Transmission Expansion Advisory Committee Supplemental Projects

PPL Transmission Zone

Changes to Existing Projects

PPL Transmission Zone M-3 Process Beach Haven

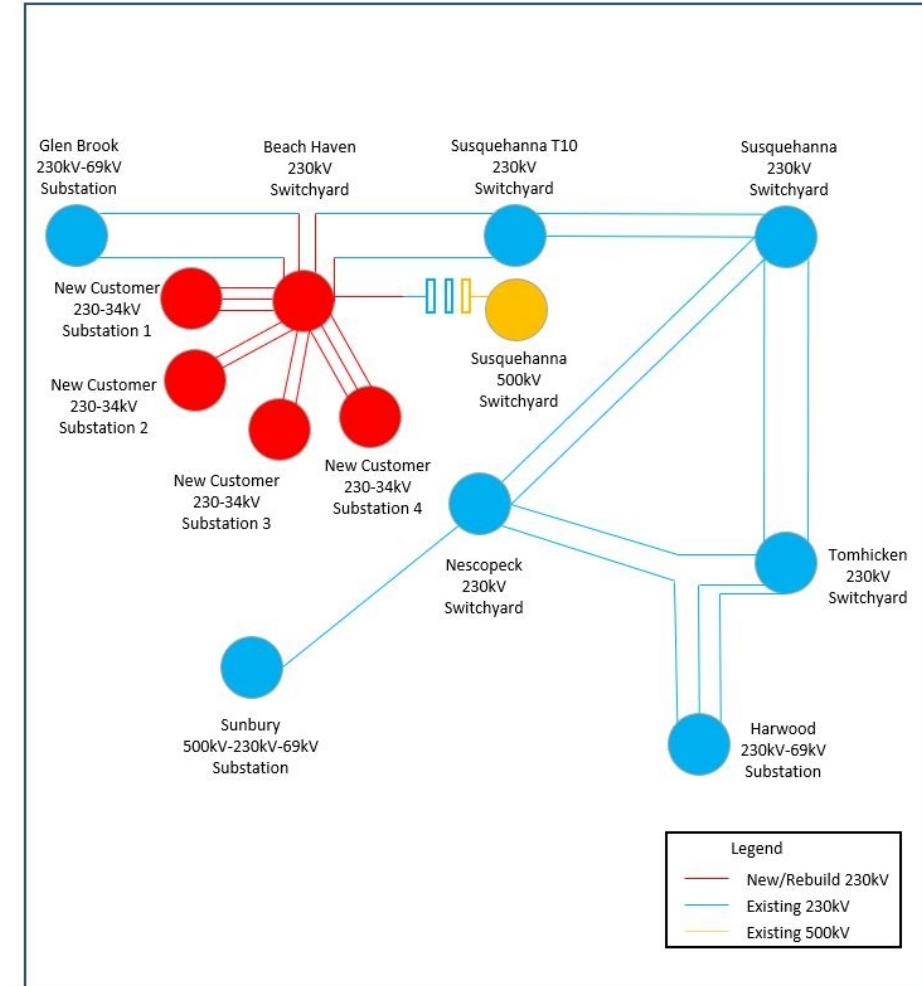
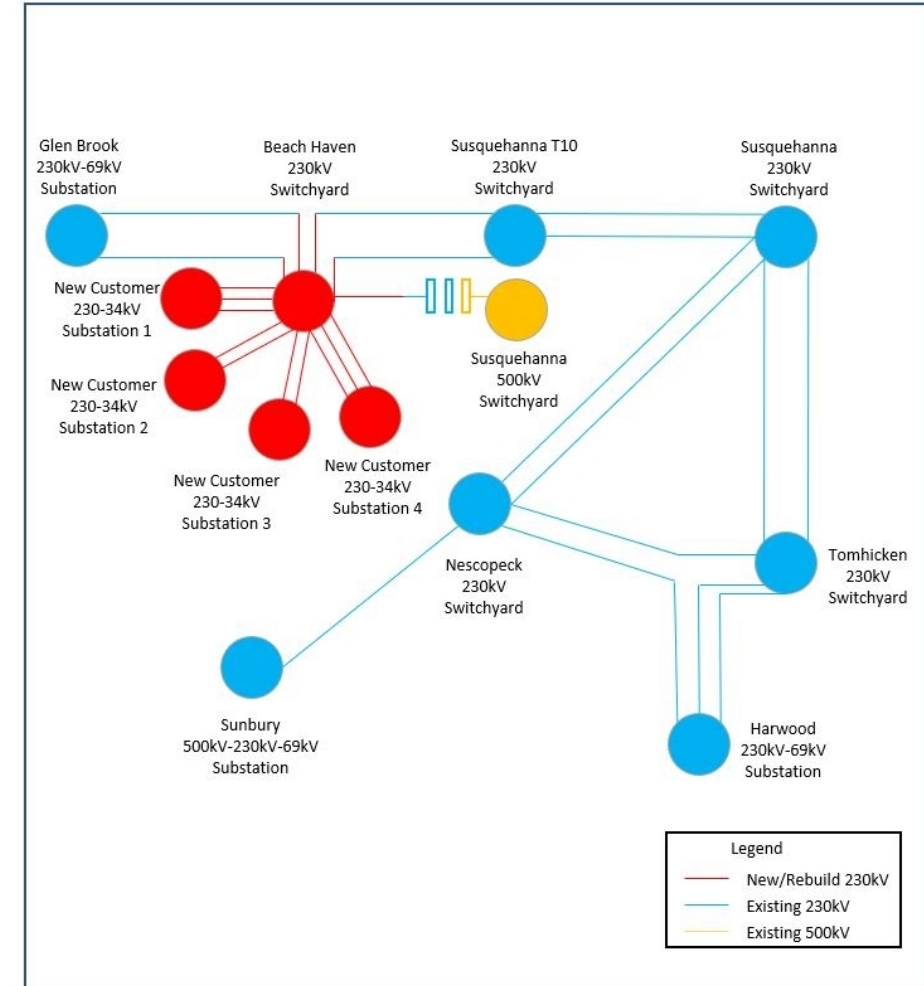
- Terminate the 230kV T22 lead line into the new Beach Haven 230kV switchyard (~0.8 miles) (Originally went to Nescopeck under PPL-2025-0010)
- Estimated Cost: \$5 M

Transmission Cost Estimate: \$~~81.2~~ 85.7M

Pitney New 138kV Switchyard

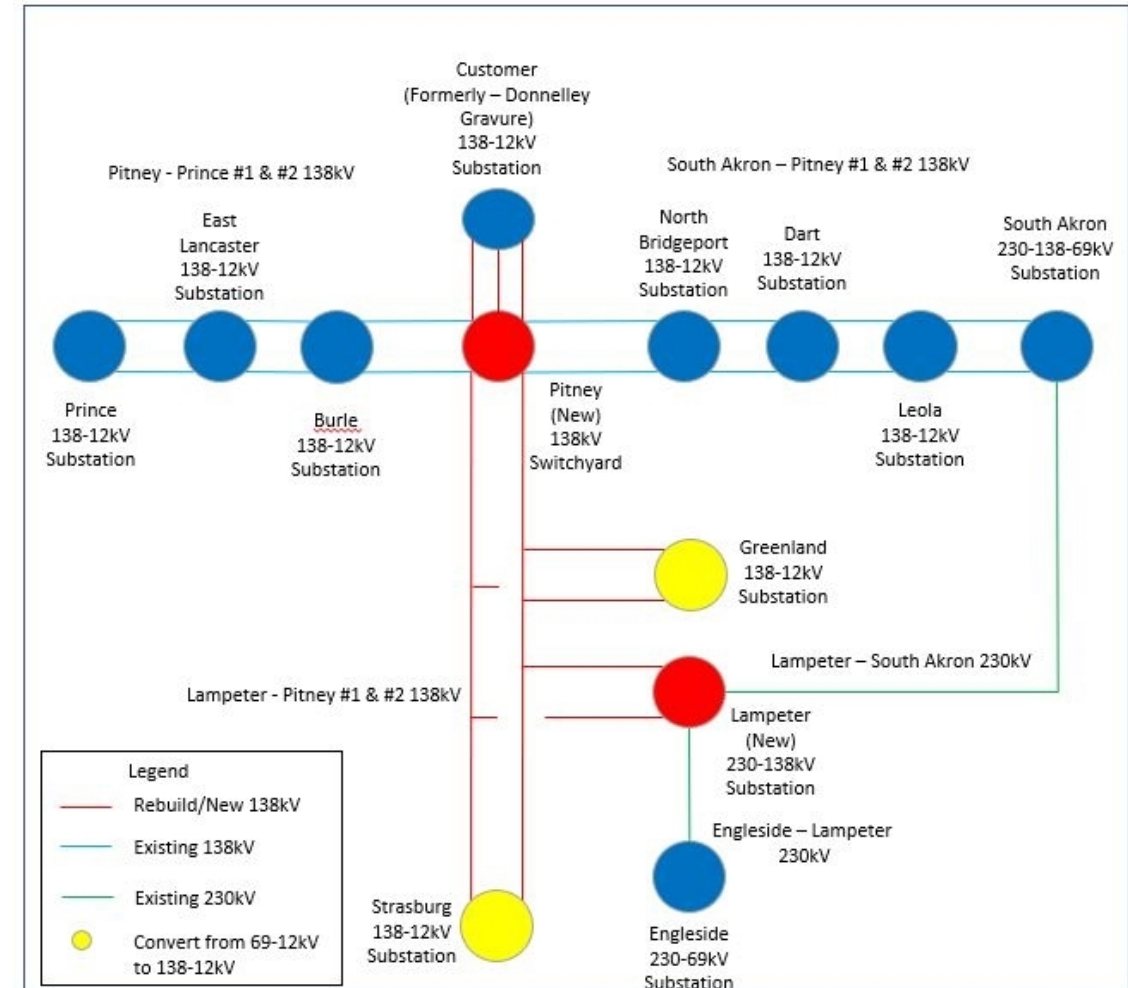
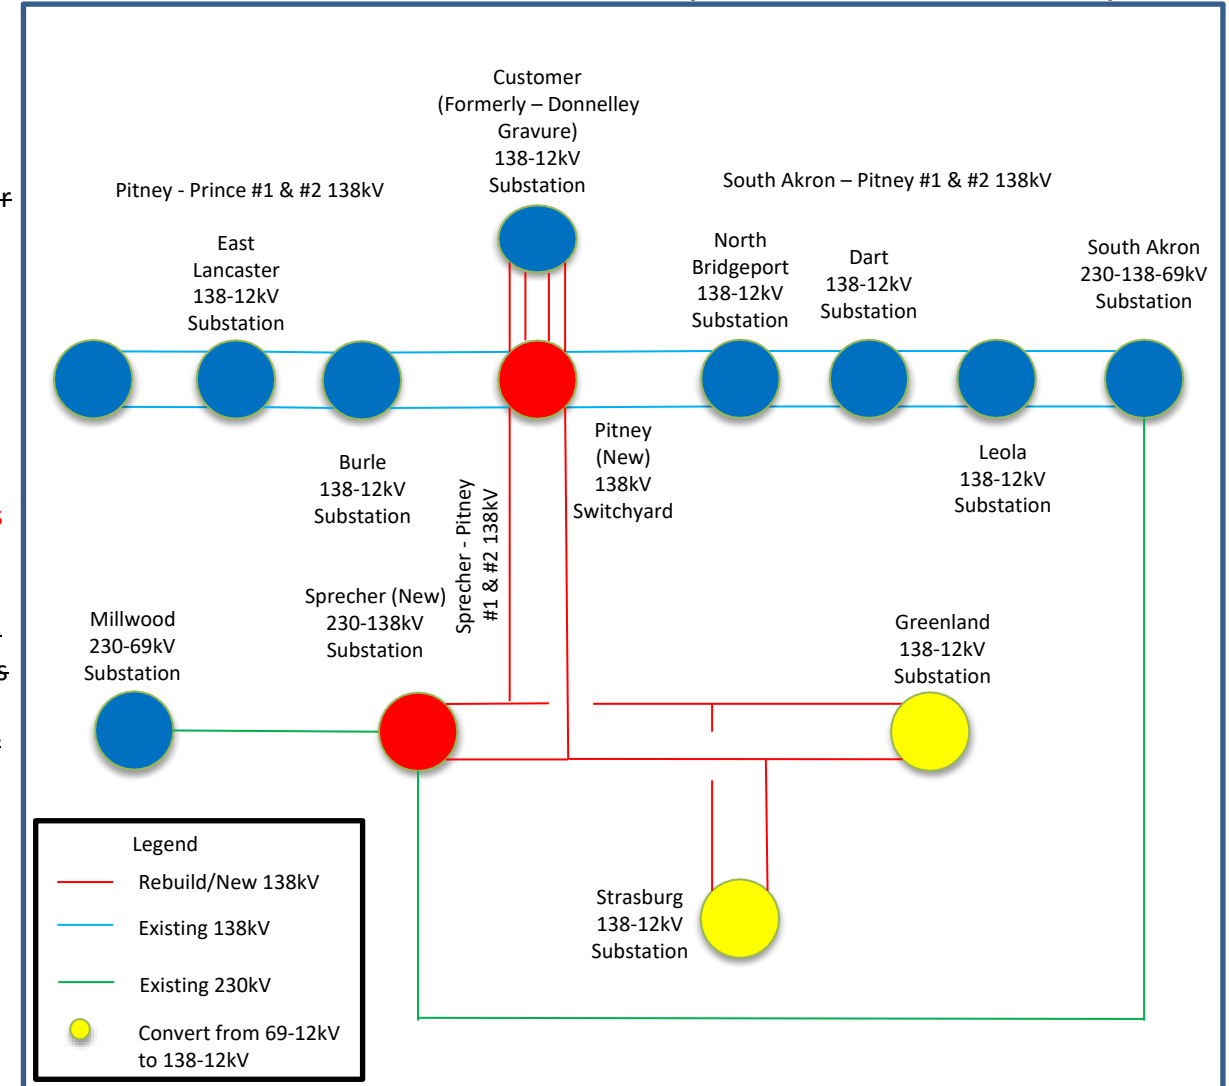
- Extend ~~three~~ **four** 138kV circuits for approximately 0.1 miles from the Pitney 138kV switchyard to the customer's facility.
- Estimated Cost: \$3.5 M

Lampeter ~~Sprecher~~ 230-138kV Substation (s3547.4)

- Bifurcate the Millwood - South Akron 230kV line and terminate at the new **Lampeter Sprecher** 230-138kV Substation.
- Estimated Cost: \$4 M

~~Lampeter Sprecher~~ - Pitney #1 & #2 138kV Lines (s3547.6)

- Rebuild 6.9 miles of the Engleside – Greenland #1 & #2 69kV line to double circuit 138kV operation from Engleside to the Greenland sub. Extend two 138 kV circuits from the Sprecher 138kV yard for ~4.2 miles and tie into the rebuilt Engleside-Greenland lines. Rebuild the 3.1-mile Strasburg #1 #2 69kV taps to double circuit 138kV operation. Extend a new double circuit 138kV underground line for ~2.5 miles from the Engleside – Greenland #1 & #2 138kV lines to Pitney 138kV switchyard.

- ~~Rebuild 3.1 miles the Strasburg #1 #2 69kV taps to double circuit 138kV operation from outside Lampeter to Strasburg substation. Extend two 138 kV circuits from the Lampeter 138kV yard and tie into the rebuilt Strasburg 138kV lines. Rebuild 3.3 miles of the Engleside – Greenland #1 & #2 69kV line to double circuit 138kV operation from Strasburg Tap to the Greenland sub. Extend a new double circuit 138kV line for ~1.5 miles from the Engleside – Greenland #1 & #2 138kV lines to Pitney 138kV switchyard. Remove a 3.6 mile section of the Engleside – Greenland #1 & #2 69kV line that will no longer be utilized.~~

- Estimated Cost: \$26 **80.1** M

PPL Transmission Zone M-3 Process Pitney New 138kV Switchyard

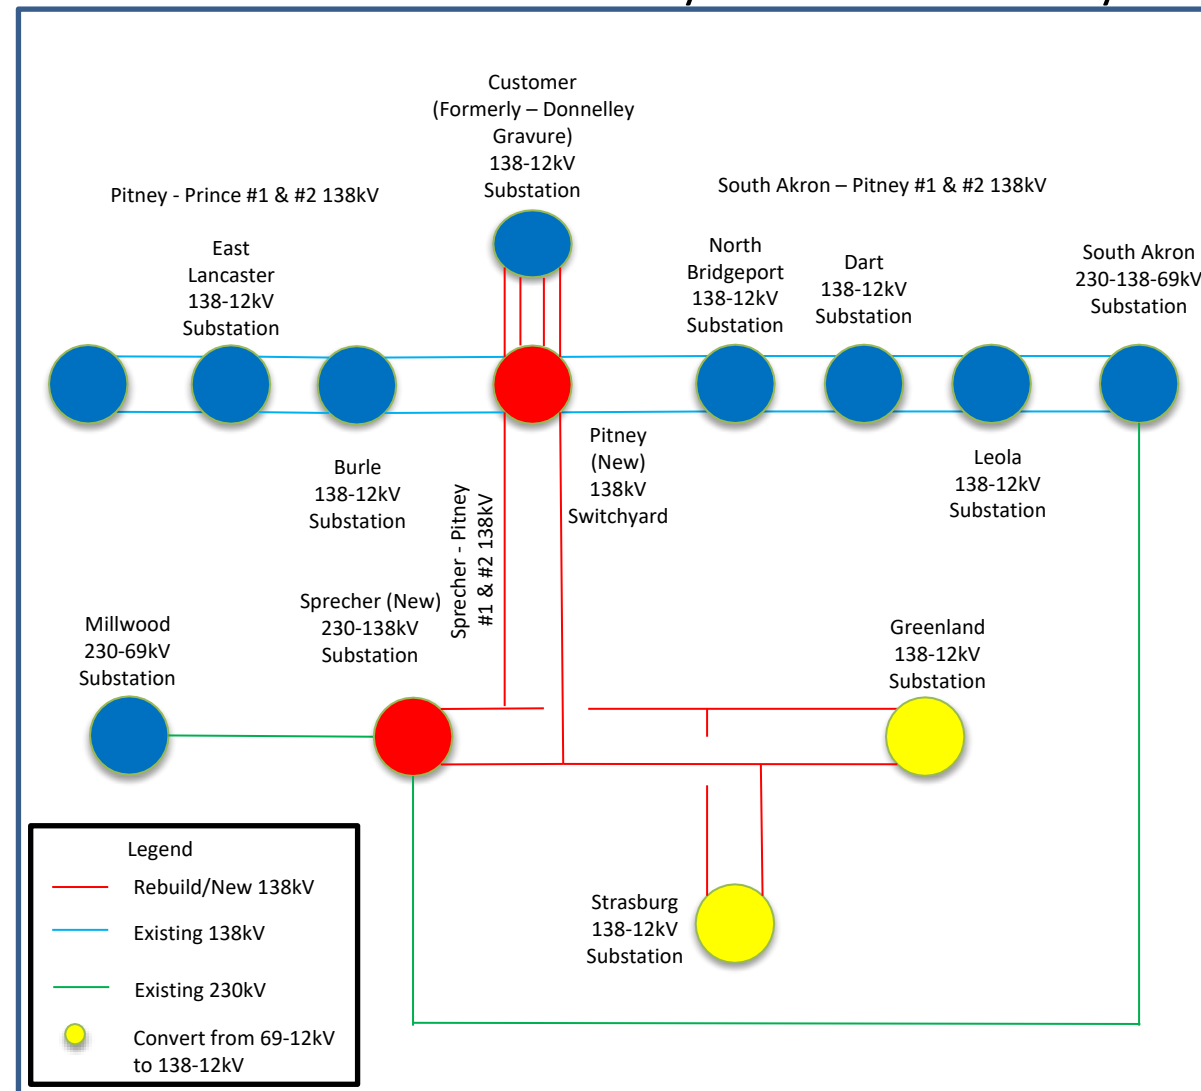
Transmission Cost Estimate: \$117.8 **171.9M**

Project Status: Conceptual **Engineering/Construction**
